COLA Part 1 Revision 1, Update Tracking Report Revision 1 (Public Version)

April 14, 2011

**Comanche Peak Nuclear Power Plant, Units 3 & 4
COL Application**

Update Tracking Report

**FIGURE 1.2-1
Simplified Ownership Diagram**

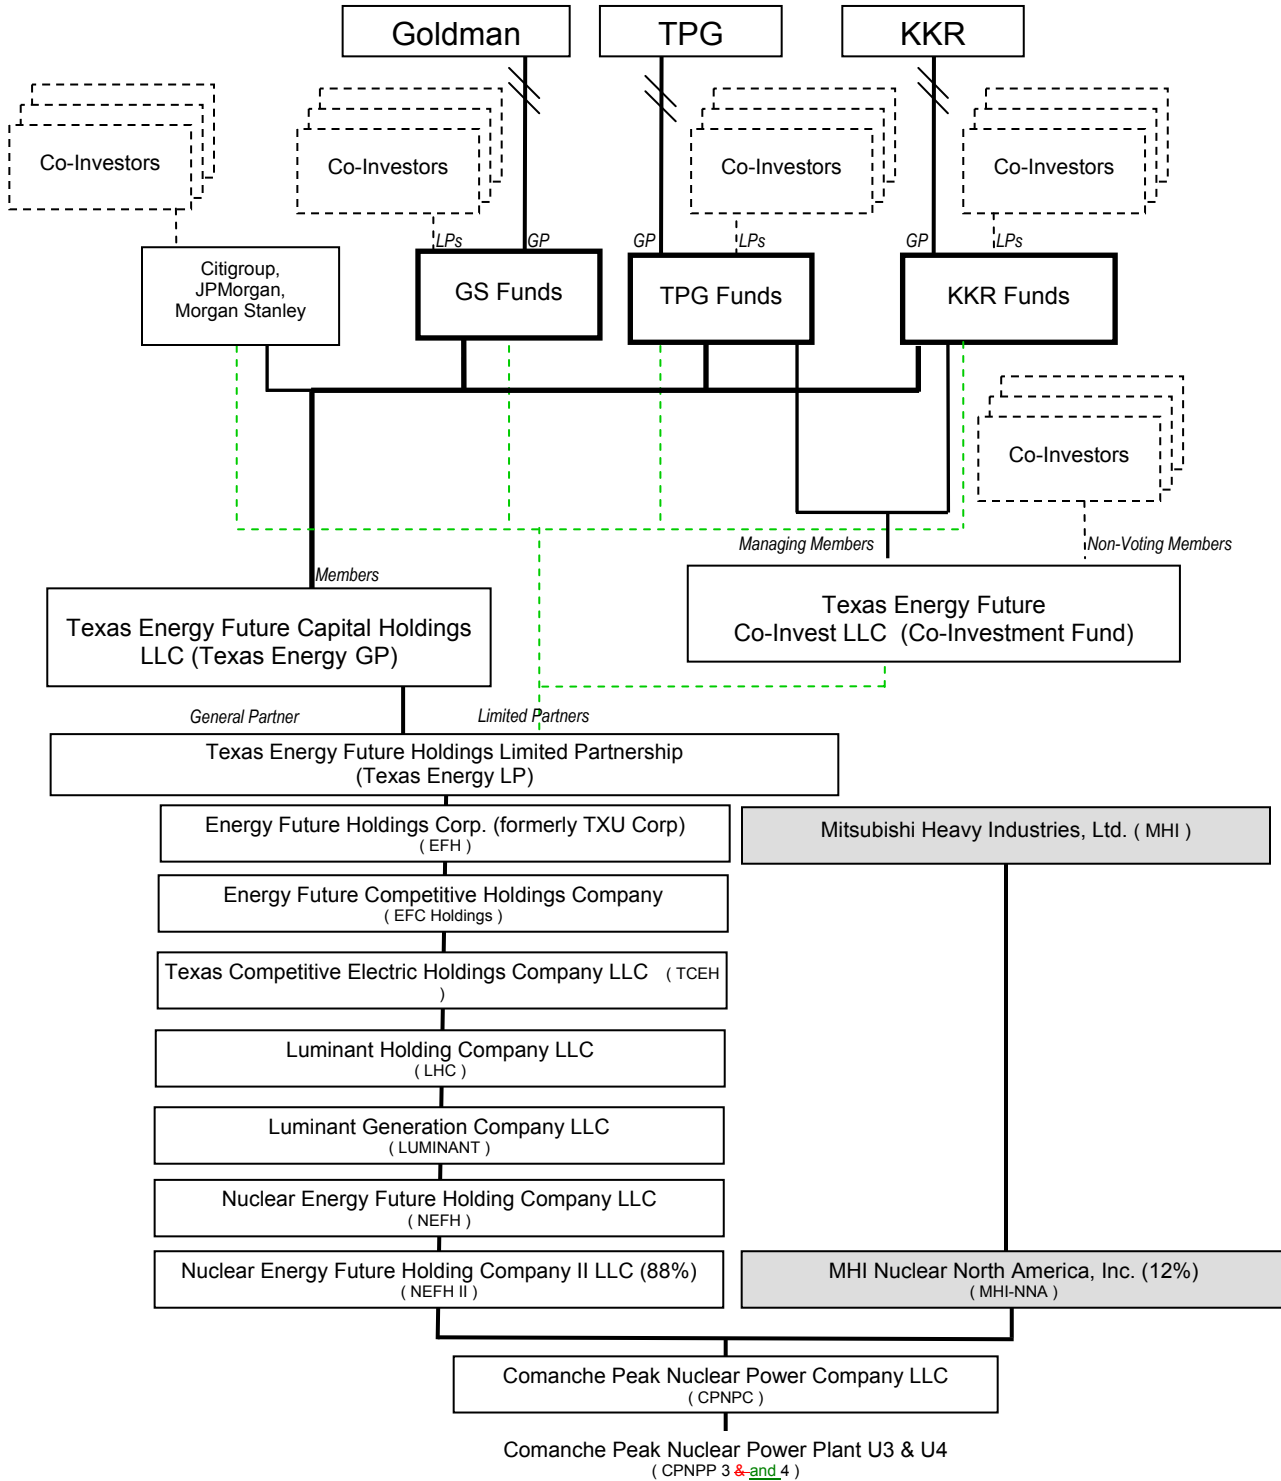
| Change ID No. | Section | GEN_FIN Rev. 1 page* | Reason for change | Change Summary | Rev. |
|----------------|---|------------------------------------|--|--|------|
| - | Figure 1.2-1 | 20 [23] | Update and replace Figure | Deleted Figure 1.2-1 and replace with new Figure 1.2-1 that has removed Lehman Bros | 0 |

| Change ID No. | Section | GEN_FIN Rev. 1 page* | Reason for change | Change Summary | Rev. |
|--------------------|---|----------------------------|---|---|------|
| - | All pages, Figure 1.2-1 Figure 1.2-2 Header | - | Editorial | Consistency of naming CPNPP 3 & 4, ensure all references are to “CPNPP 3 and 4”. | 1 |
